MANATEE COUNTY FLORIDA

SUBJECT: Invitation for Bid #09-0141DC Lift Stations Rehabilitation
Bayshore on the Lake, Mirror Lakes, Samoset 1

ADDENDUM #1

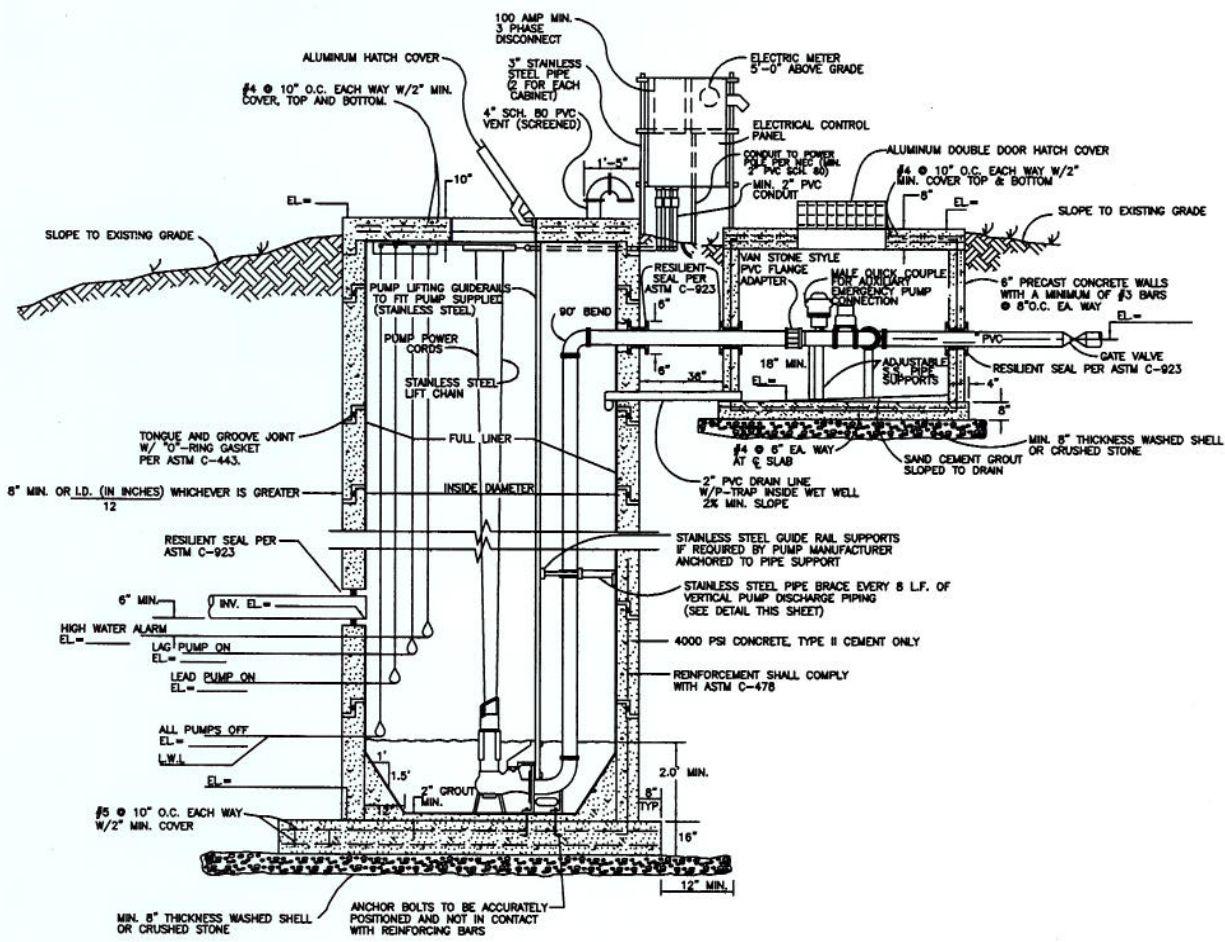
12. There is no water service to be connected at Mirror Lakes. The water service is hereby deleted from the scope of work. The work schedule on Sheet 4 under Proposed Mirror Lake Water Improvements is hereby revised to read "NO" and the words "UPGR. TO U-15 DET/DWG 6" shall be deleted. Bid Form item 26 is deleted.

SECTION X-X
FOR PLAN VIEW
SEE SHEET US-20A

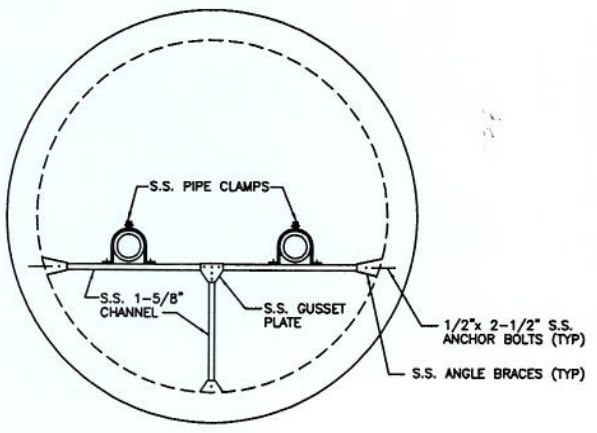
11. What is the minimum clearance required from piping in the valve vault to the floor and vault lid? Manatee County Standard Plan US-20B indicates 18 inches minimum clearance from piping to the floor and the project plans Sheet 4 Elevation indicates 24" minimum from the piping to the vault lid. (Detail attached)
